17 March 2015
Our Ref: 6131N.30ER

**Section 75W modification of Project Approval issued for MP09_0180
34-36 Memorial Avenue, Kellyville
Modification of Clusters 1 and 5**

D	Cluster 5 Amendments	11/03/15
C	Dept Of Planning Issue	11/12/14
B	Prelim Dept Of Planning Issue	28/11/14
A	Section 75 amendment	31/10/14

536C5_ DA_ 75W_3.15 D

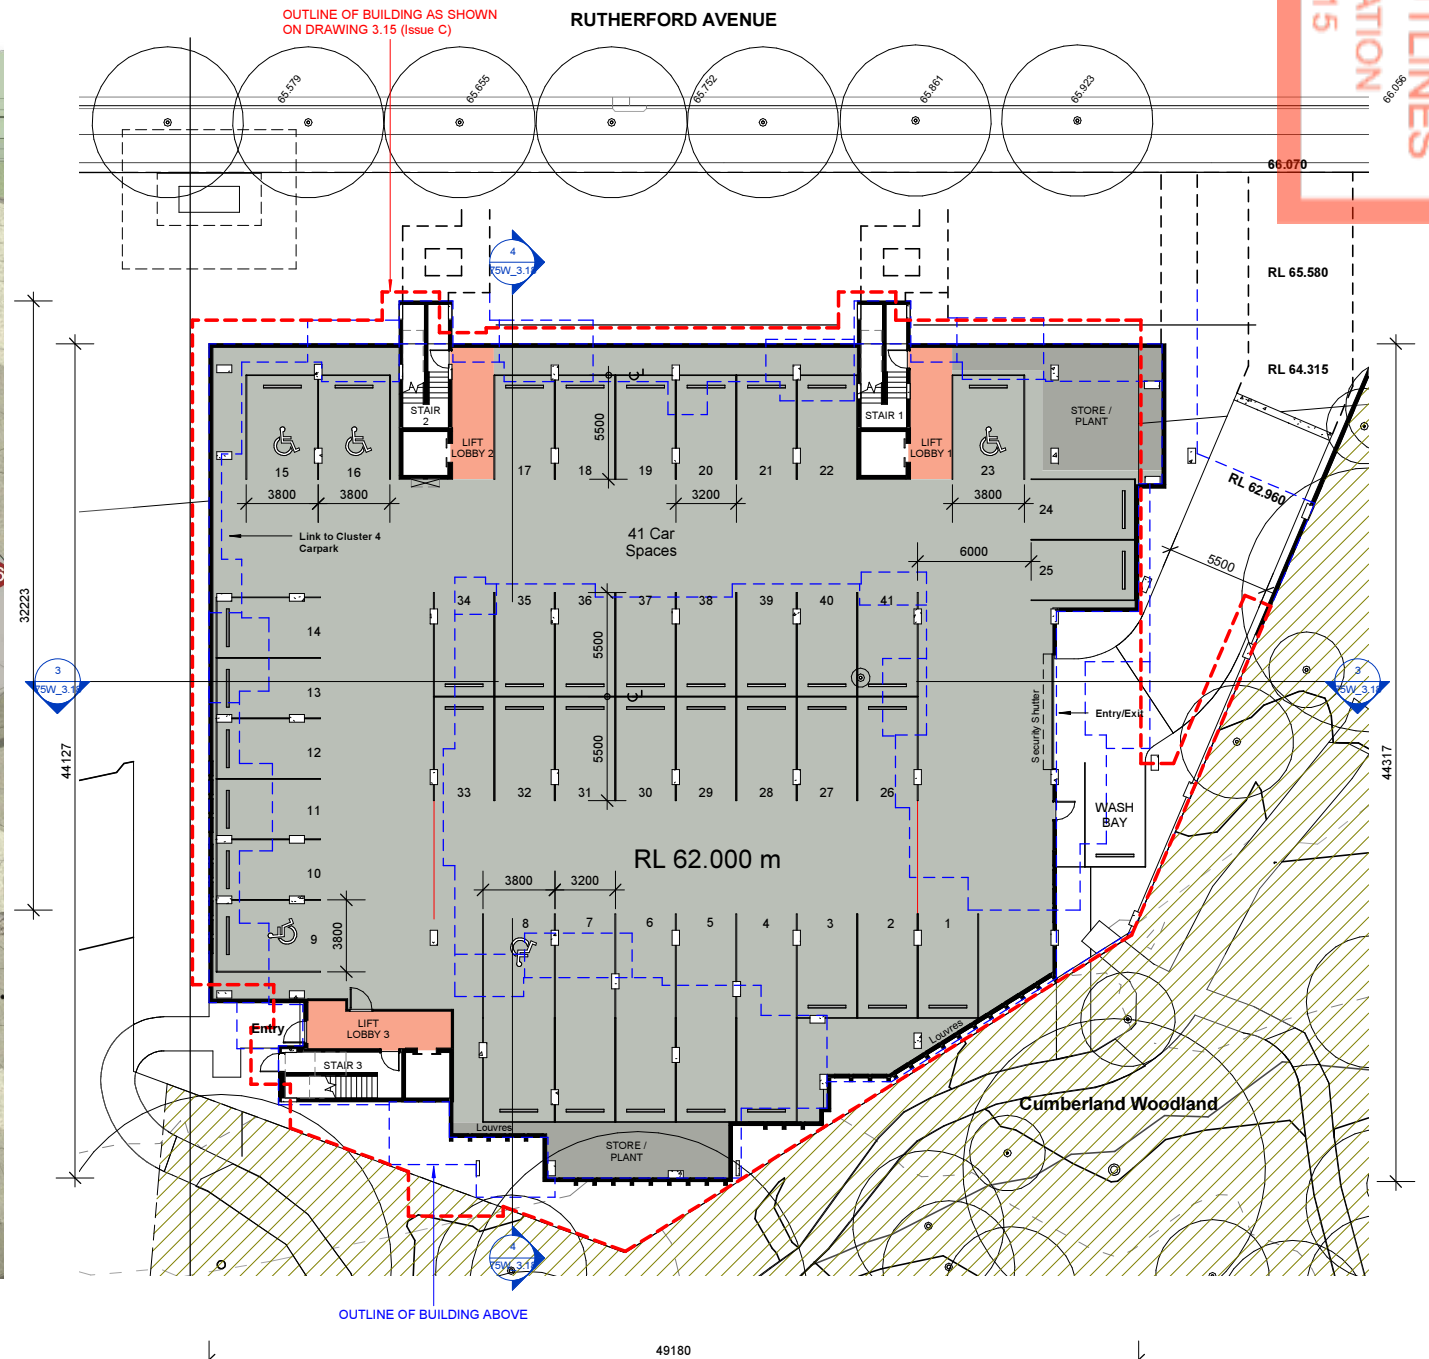
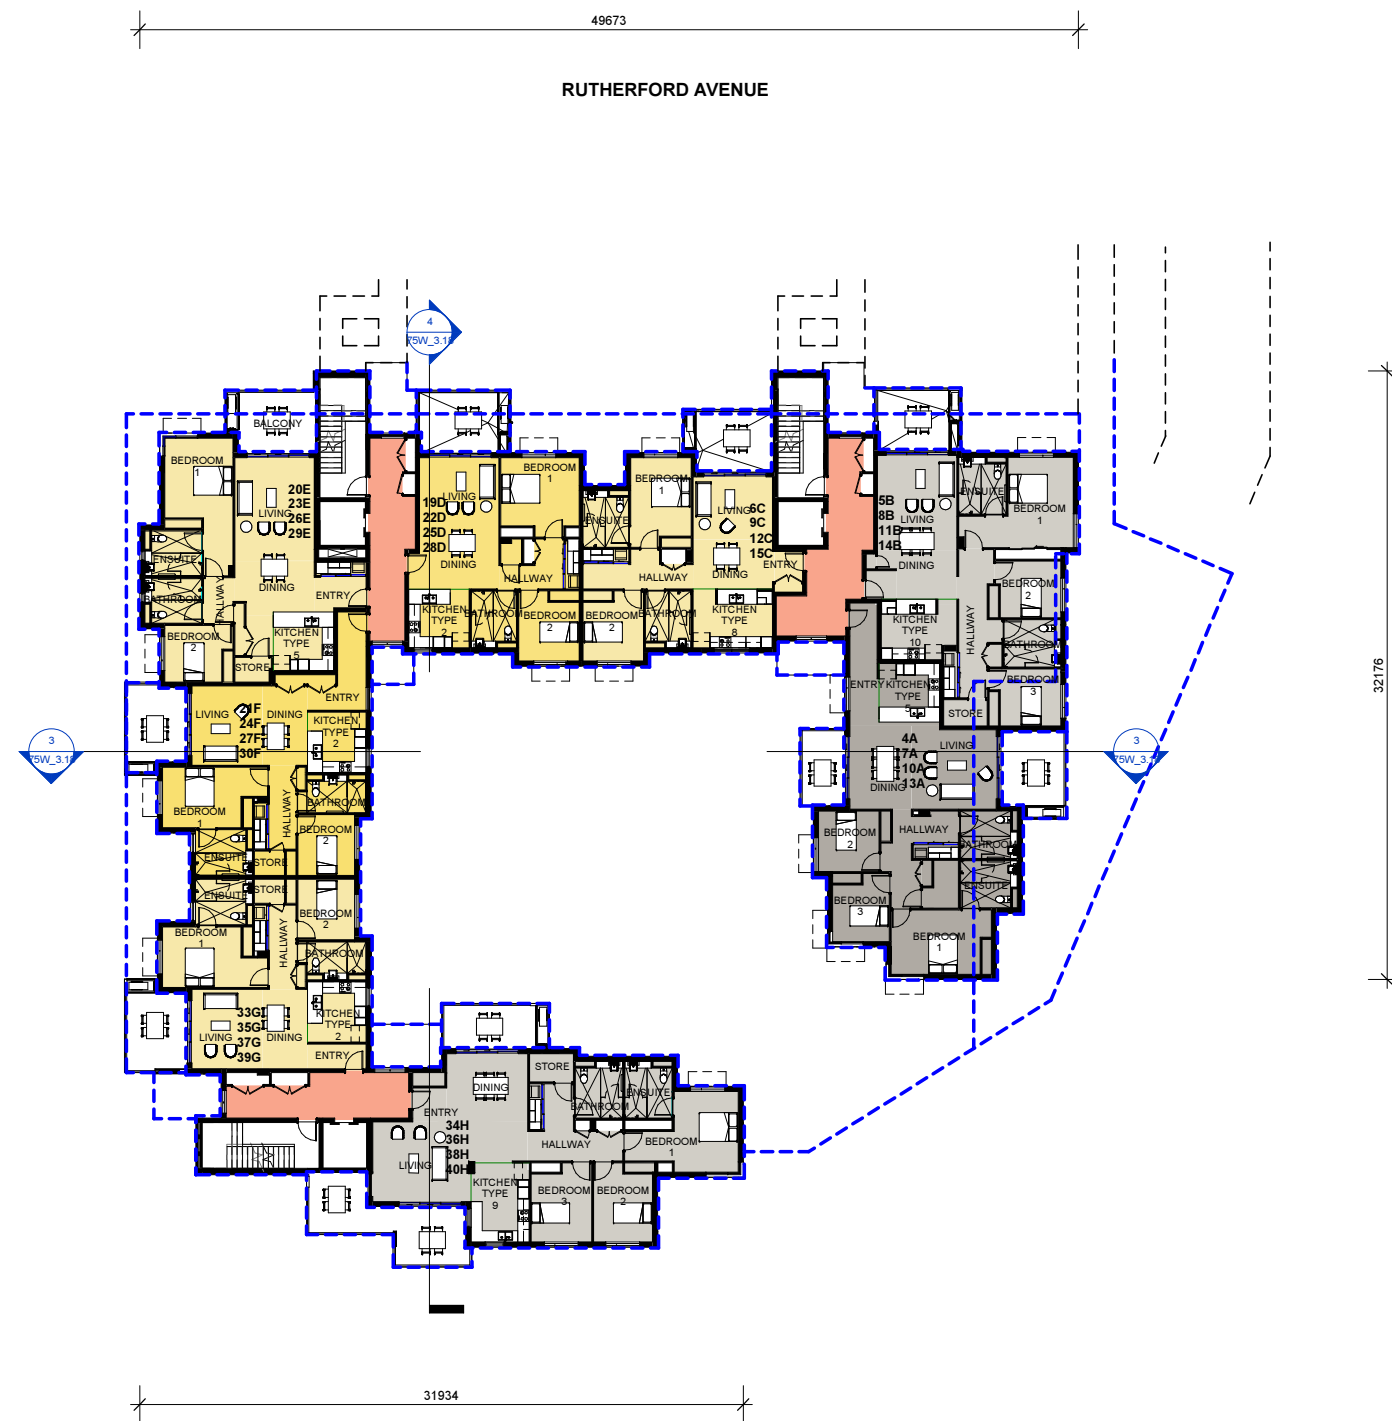
- A redesign of the basement level to reduce the size of the basement footprint. The car parking layout has been modified however a total of 41 car parking spaces will continue to be provided. The number of car parking spaces which are 3.8m wide (to comply with the provisions of Item 5 of Schedule 3 of SEPP Seniors) has been reduced from 7¹ (as shown on the plans submitted on 15 December 2014) to 5 however, overall, the number of 3.8m wide spaces for the entire development will exceed the minimum requirement of 46 spaces.

- The layout and floor plans of the apartments have been varied slightly to make more efficient use of space. The number of apartments proposed will be the same – (40) but the total amount of floor space per level will reduce from 980sqm to 897sqm – a reduction of 83sqm per level. This has been achieved through some internal reconfiguration of rooms and variations to the building footprint.

The most significant change has been in relation to new Apartment Type H (previously identified as Apartment Type G). The revision provides for an extension of this 'wing' of Cluster 5 building to the south however the building will not encroach beyond the boundary of the area identified as the Cumberland Plain Woodland reserve in the Section 88B restriction as to user that applies to the site and the development.

On the ground floor level, additional semi-private spaces to Apartment Types A, C, D and H have been provided as paved spaces within the internal common courtyard.

Also on the ground floor level, on areas above the roof slab of the parking level, the private open space areas for apartments on this level have been increased rather than leaving areas of vacant unused space.

D	Cluster 5 Amendments	11/03/15
C	Dept of Planning Issue	-
B	Prelim Dept of Planning Issue	-
A	Section 75 Amendment	-
Rev:	Amendment:	Date:
Scale: @ A1	Date:	Drawn:
1 : 200	03/16/15	Author
Project #:	Drawing #:	Checker
536C5_	DA_ 75W_3.16	D

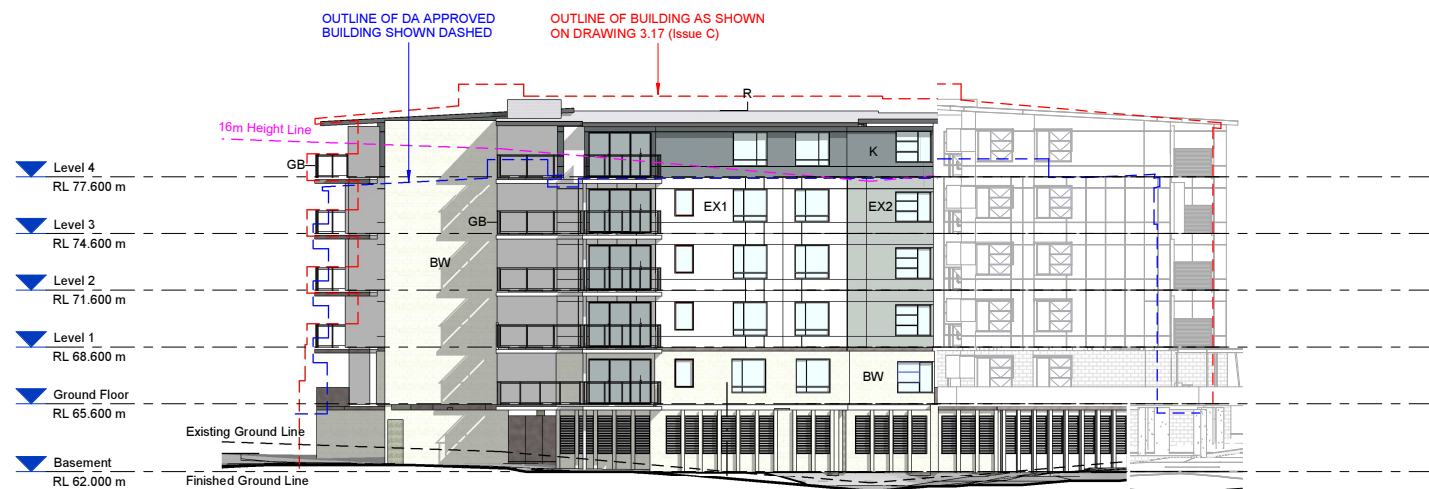
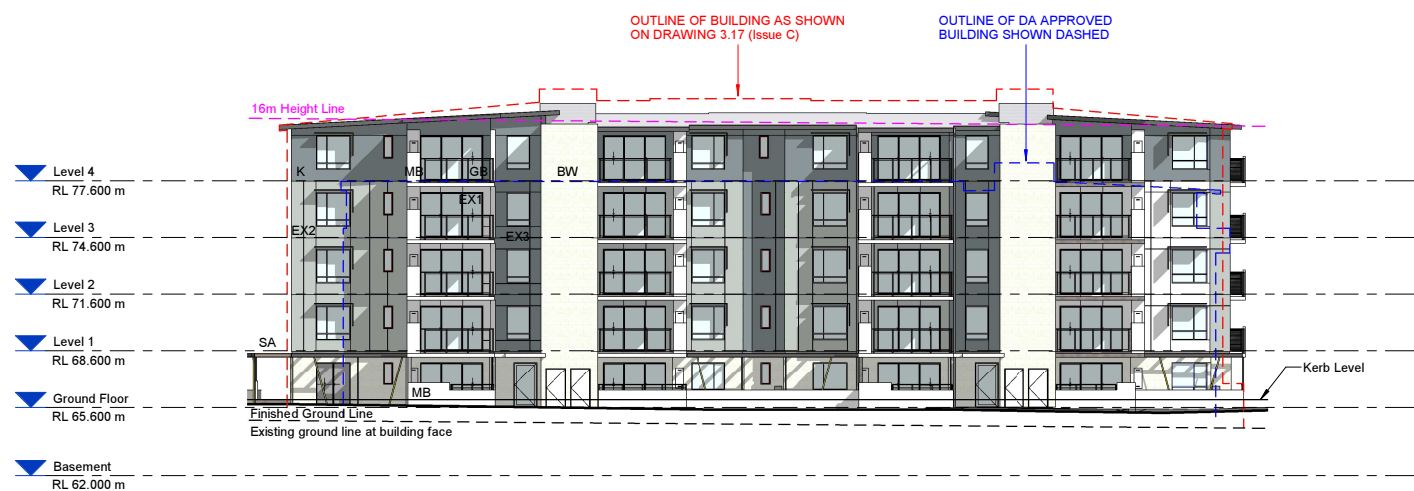
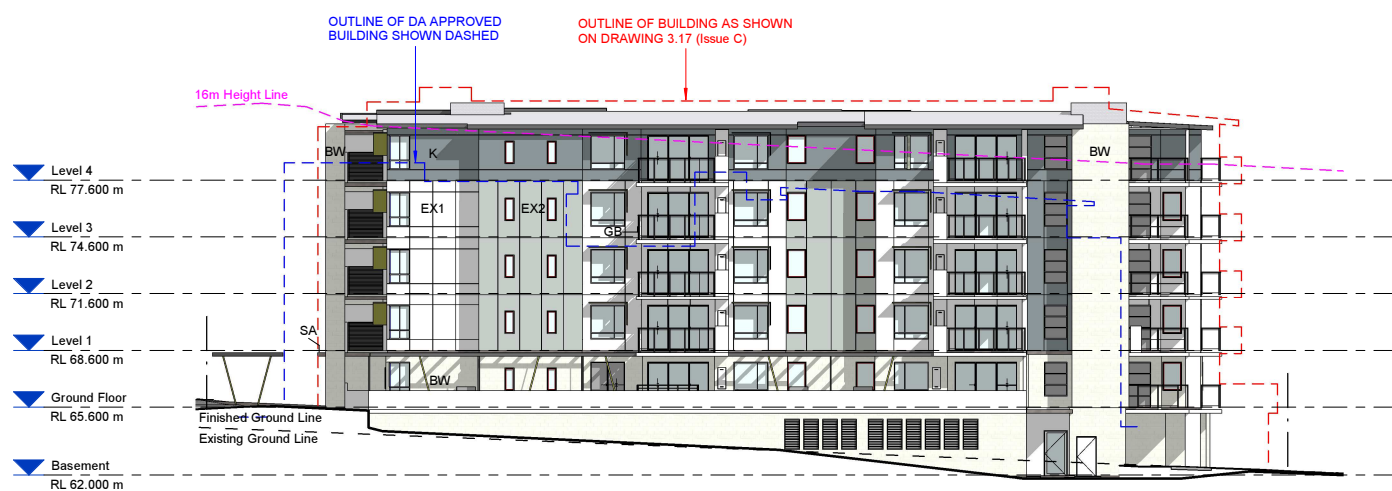
Along the Rutherford Avenue frontage the balconies have been staggered to provide interest and articulation to this elevation.

An additional balcony has been provided to the northern elevation of Apartment Type A to improve solar access to the private open space of this apartment type. An additional balcony has been added to the eastern side of Apartment Type H to increase the private open space provision to this apartment type.

- Overall the building has been reduced in size and height.

Attachment A to this letter is a set of revised plans which identify the approved Cluster 5 development (blue dashed line) and also show the outline of the building as per the December 2014 modification submission (red dashed line). The reduction in the building height and increase in the setback to Rutherford Avenue is apparent in these drawings.

536C5_ DA_ 75W_3.15 D

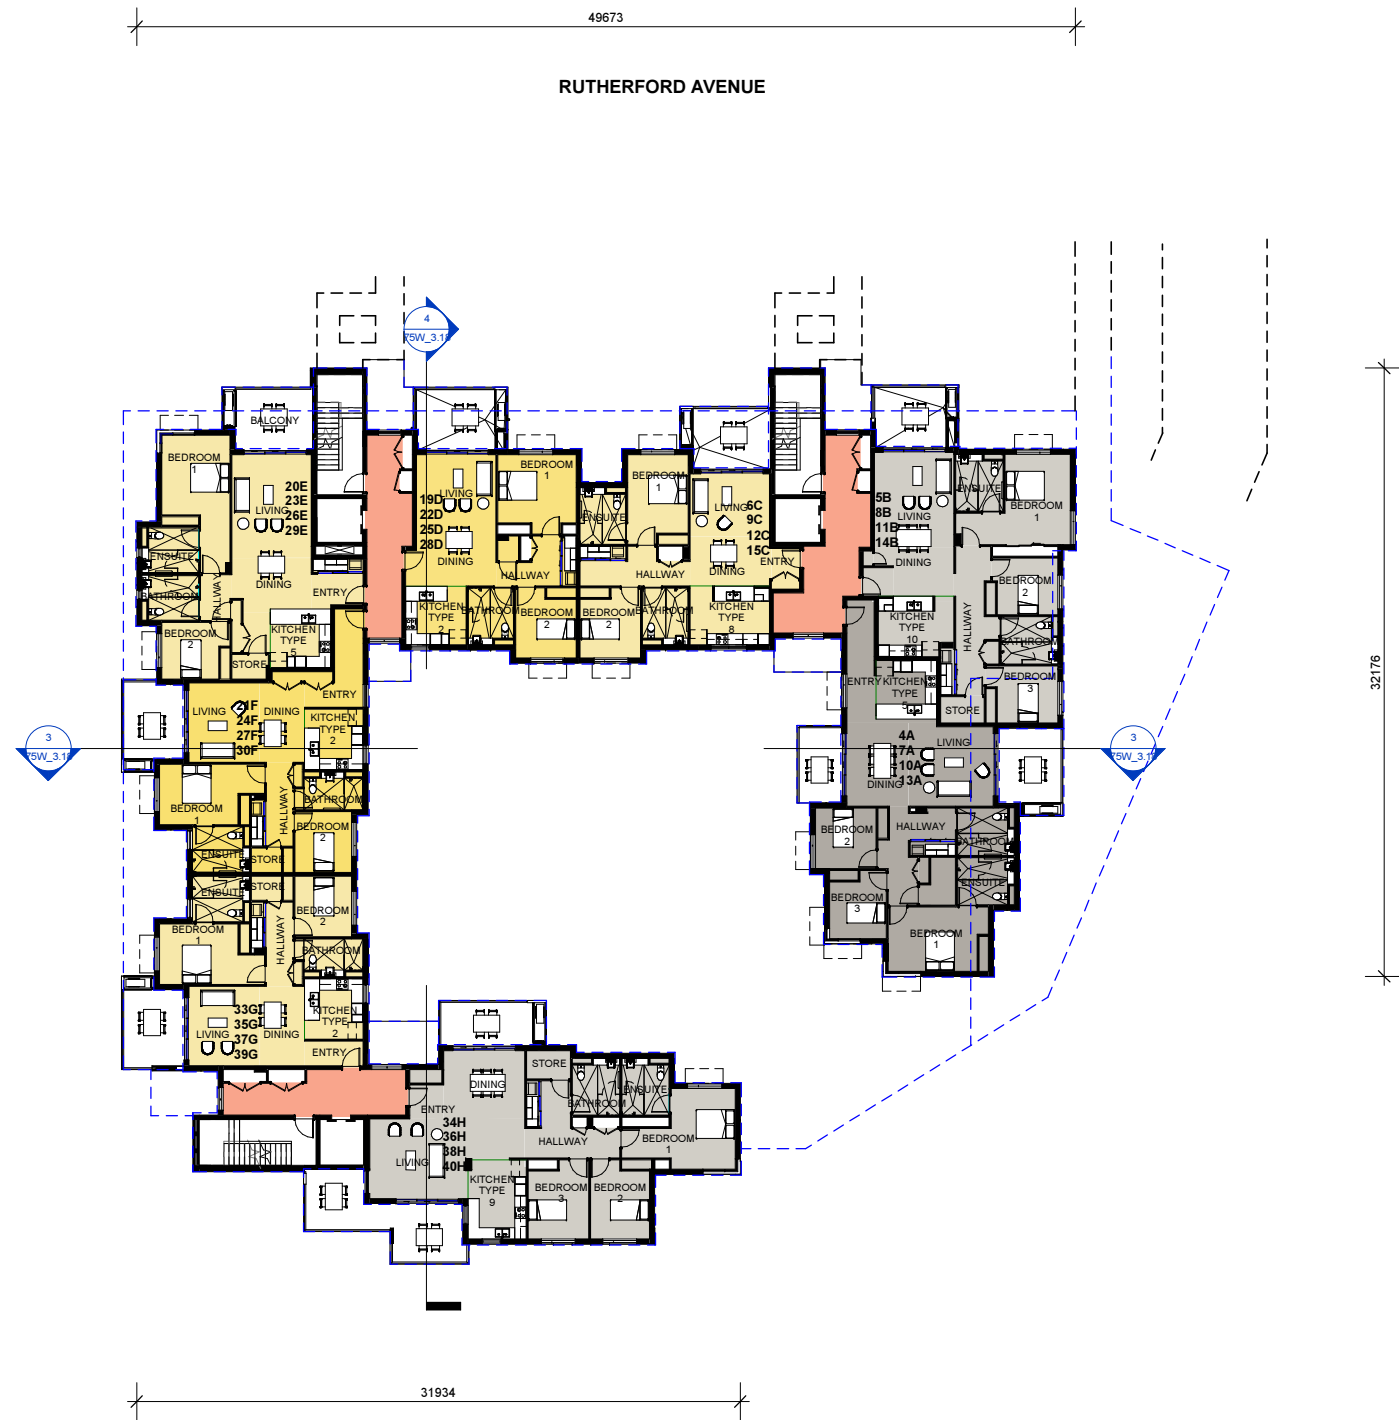
Attachment B to this letter is a set of revised plans which identify the modifications to the approved layout of Cluster 5.
